AMENDMENT OF SOLICITATION/MODIFICATION OF CONTRACT

0001

DTFAEN-11-R-00026

RE: ELEVATOR REFURISHMENTS: FLO, MYR and GSO.

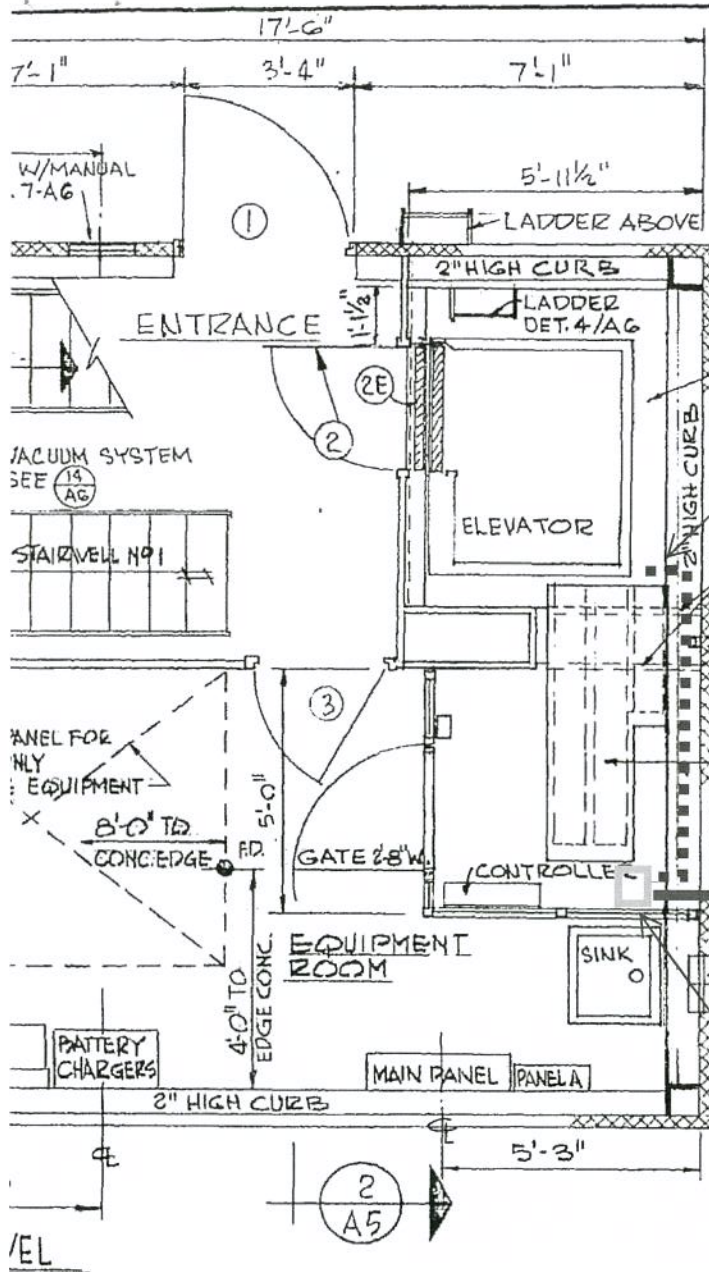
Scope for Florence ATCT states that the existing elevator sump pump is to be replaced in addition to a new back-up sump pump installation, with battery back-up & accessories. There is no existing sump pit or pump in the elevator shaft (see attached photo of FLO ATCT Elevator Pit). In order to install scope items 49, and 50, the basin of the pit would require demolition/excavation to create a sump pit in the concrete shaft basin. Is this what the FAA desires?

Florence ATCT elevator sump pump is to be mounted within the equipment room area with a remove float switch and piped suction line in the corner of the existing pit. Outlet will be routed to exterior wall through the equipment room. See attached sketch RFI-001
